Final Report – Design Review Committee on Village at Squaw Valley

The task before the Squaw Valley Design Review Committee (DRC) was to analyze the Design Guidelines written into Appendix B of the Squaw Valley Real Estate (SVRE/Applicant) Village at Squaw Valley Specific Plan (Specific Plan). Where appropriate in their view, the DRC was to make recommendations for modifications and/or additions.

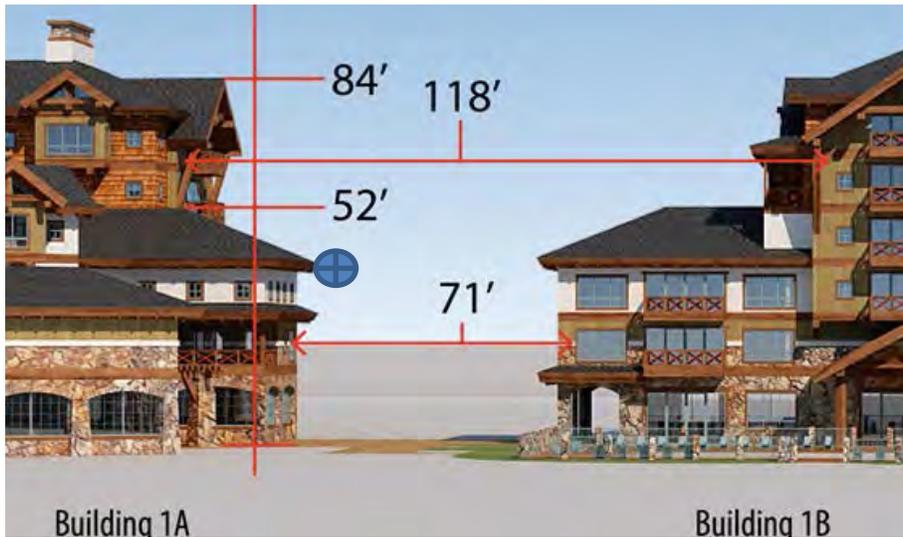
As can be seen in Figure 2, the applicant’s revised layout for VC–C (September 2015) has substantially opened up the separation between buildings, and in most instances, the separation exceeds the minimum of 40 feet for passageways.

A graphic helps to explain this.

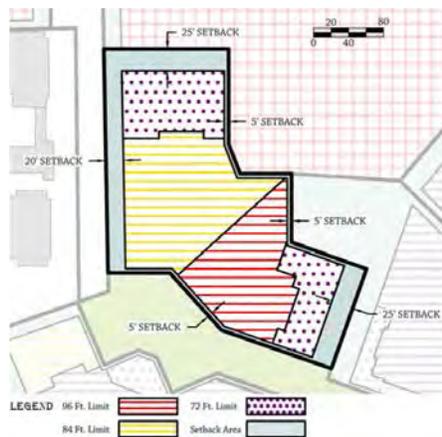
2. Sense of Enclosure (building height to building separation ratio) – A key metric in determining the feeling someone gets when walking down a passageway is the ratio of the width of the passageway to the building height immediately adjacent to the passageway. This is defined as “sense of enclosure”. The smaller the ratio, the more “closed-in” or “urban” the feeling. The larger the ratio, the more “open” or “rural” the feeling. The Design Guidelines specify that “*the general building to building separation setback ratio should be 0.4 (four feet separation for every 10 feet in building height)*” (page B–12). This is as compared to a ratio in the IntraWest Village of 0.8 (40 foot passageway width and 50 foot building heights). The DRC felt the 0.4 ratio was inappropriate for the proposed Village passageways because it creates a more urban feel.

- The building separation to building height ratio must be at least 8 feet separation for every 10 feet in building height (0.8) for passageways, and 6 feet separation for every 10 feet building height (0.6) for paths. A consistent 0.8, or even better 1.0, is preferred. The height of the building for this ratio is measured from the level of the pedestrian passageway, which may not be at ground level, to the top plate of the wall adjacent to the passageway.

At the pedestrian plaza level, the building separation is 71 feet, thereby dictating that the height of the adjacent wall, measured from the pedestrian level to the top plate (the \oplus symbol in the above graphic), must be no more than 56.8 feet ($0.8 \times 71 = 56.8$). The opposing stepbacks are 118 feet apart, so the maximum height to that top plate must be no more than 94 feet.

SVRE Response: Agreed (clarifications and/or differences have been incorporated)

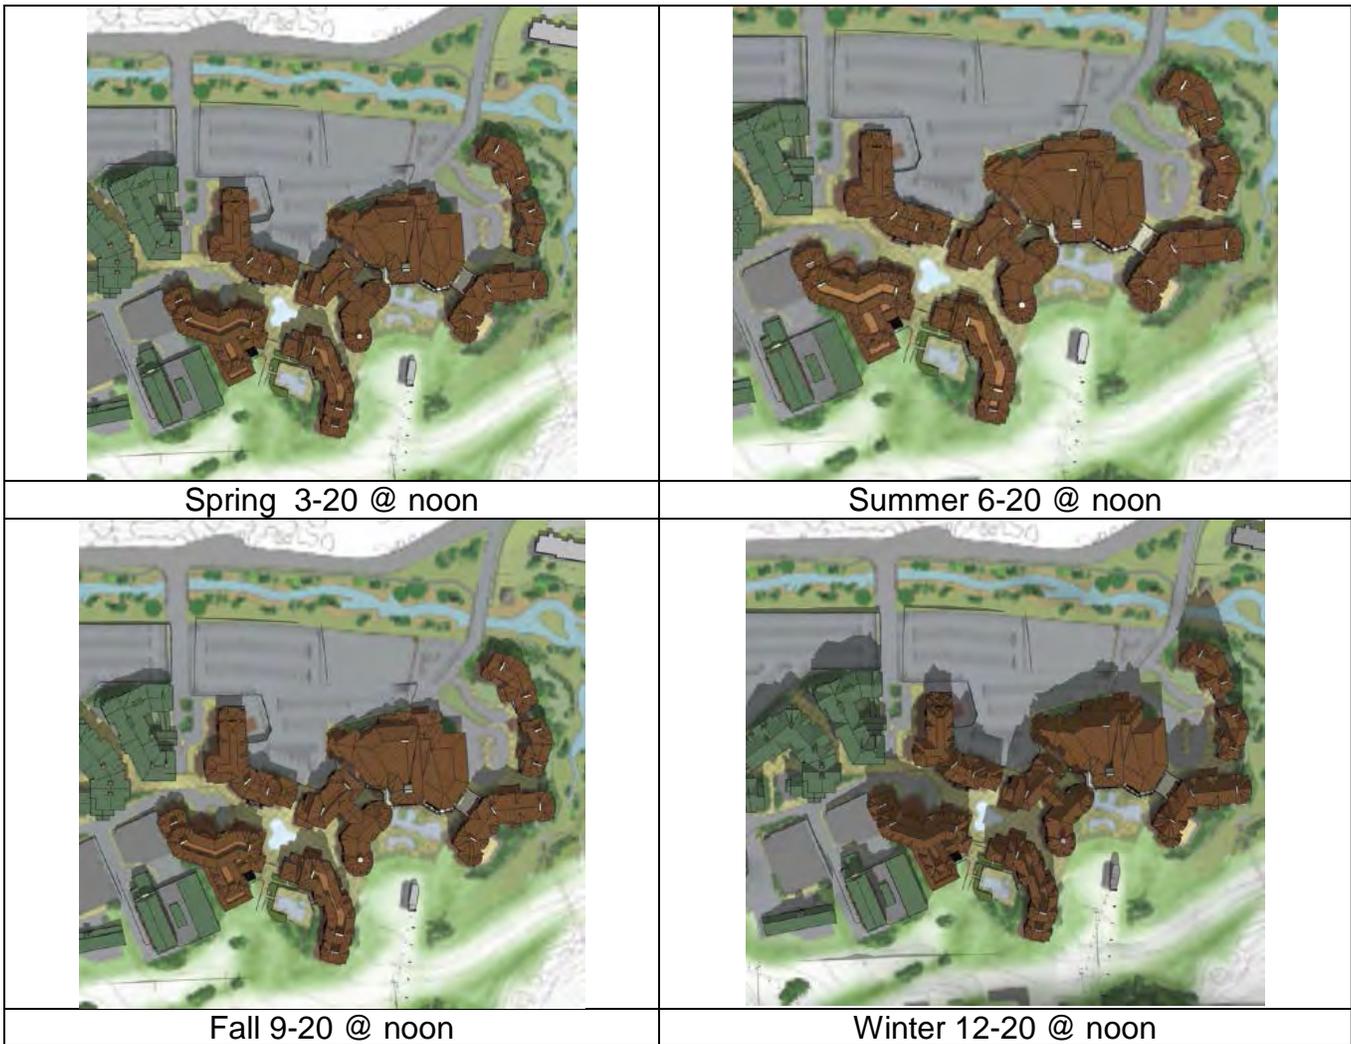
4. Pedestrian Plaza – lot 33 is designated as an open space area, and the impression is that it is to be a main gathering area and would contain an ice rink, as is so designated in Figure 4.1 of the Specific Plan. However, this lot is extremely narrow, and often shadowed throughout the year, especially in winter – a prime tourist season (ref dEIR, App F Shadowing). The DRC felt that either the applicant should give up on Lot 33 being a gathering area, or preferably, size it more appropriately.

- The Village Core–Commercial shall be comprised of a network of pedestrian streets and landscaped corridors, which shall converge at the **main pedestrian plaza** and shall be populated with smaller gathering spaces, passive and active recreational nodes, and other points of interest
- This main public pedestrian plaza shall be prominently located, a minimum of .75 acres in size, have open access, and be included within any VC–C development. Referring to the Sept 2015 SVRE VC–C layout (Figure 2) this plaza would comprise the center section of Lot 33, the passageway between building 1A and 1B, and the hardscape area between buildings 1A and 1B (See figure below).

SVRE Response: Agreed (clarifications and/or differences have been incorporated)

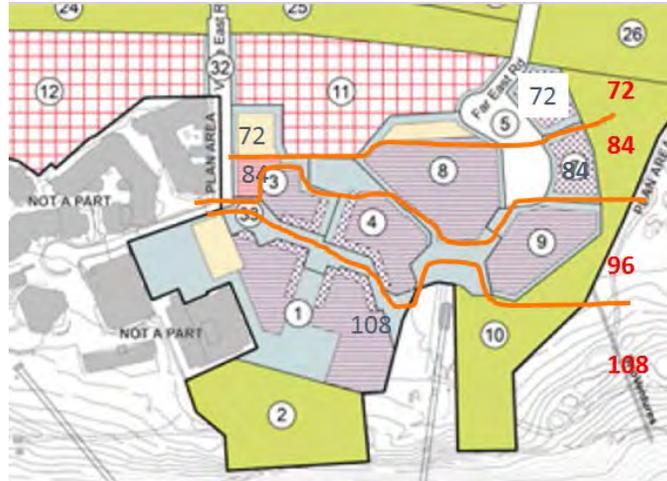
The DRC felt that the view obstruction could be minimized by arranging the maximum allowable building heights in a stepped manner, as shown in this image from Mt. Tremblant with shorter buildings in front, away from the mountain, and taller buildings in the back, closer to the mountains.

The DRC decided to require this arrangement.

- Buildings shall be arranged in VC-C with generally shorter buildings to the North and taller ones to the South, with a one floor minimum difference in max height between “steps”.
- The “steps” in Height Arrangement Standard for VC-C shall be arranged starting from nominally 72 feet (or less) to the North and stepping to nominally 108 feet (or less) to the South, with a one floor difference in maximum height between “steps”.
- Step boundaries must be recognizable, but may be irregular

An example of how these step boundaries might appear for VC-C was created for illustrative purposes (this graphic was developed from a graphic included in the October 2014 Specific Plan).

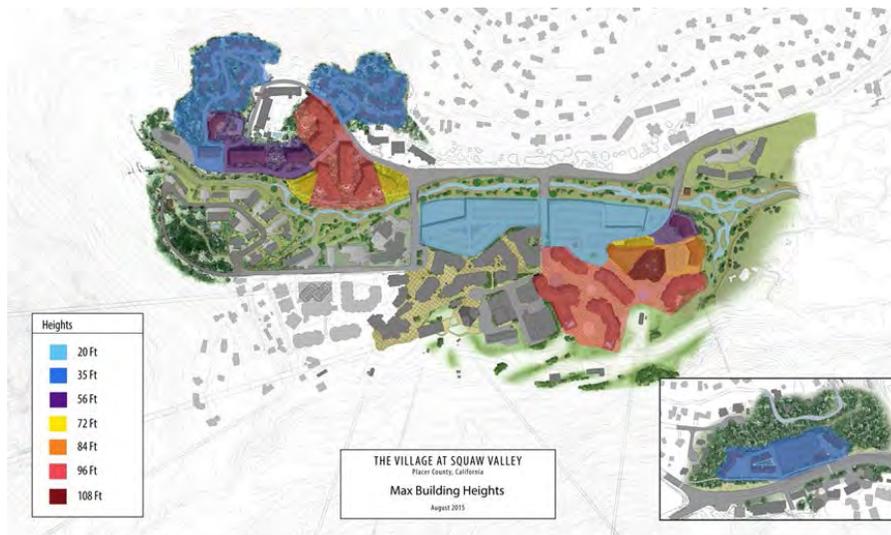
SVRE Response: SVRE agreed to the concept and presented the exhibit below

The DRC does not accept this proposal, and remains at odds with the applicant on this recommendation. There is no height stepping from Buildings 3 and 4 to Building 1A and 1B, and the MAC remains a problem. While the northern most section of the MAC has been reduced in height, the southern 108-foot tall section still dominates the entry and street view, and its view line hits the Snow King mountain side at least 100 feet higher than other view lines. The DRC recommends that the MAC fit in with the step height arrangement by either being moved or lowered in height.

The image below from the Base Camp model highlights the three buildings of Lot 13 – Building 13C to the East (left in image) and 13A to the West (right in image).

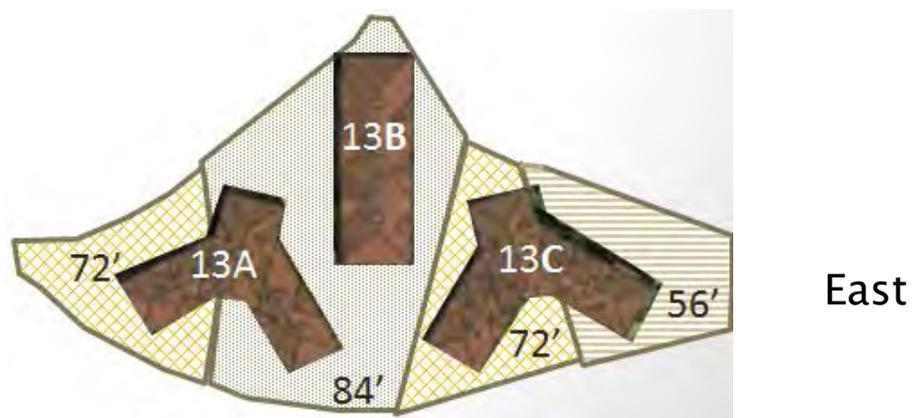
The DRC concern was the allowed height profile of Building 13C. From the Design Guidelines Lot 13 development standards (page B-26), the entire building could be as high as 96 feet. It was felt that such a tall building will appear overwhelming as one approaches the VC-N area along Squaw Valley Road, and its profile will block the view to the Tram Face to the west. This was confirmed by the applicant at the DRC presentation on August 17th, even though the easternmost section of building 13C had been lowered to 72 feet.

- Buildings in VC-N must abide by the Building Shape Design Standard.
- The Height Arrangement Standard does not apply in VC-N except for Lot 13. The maximum allowable heights in Lot 13 will be determined by this Lot drawing (or a close approximation thereto)
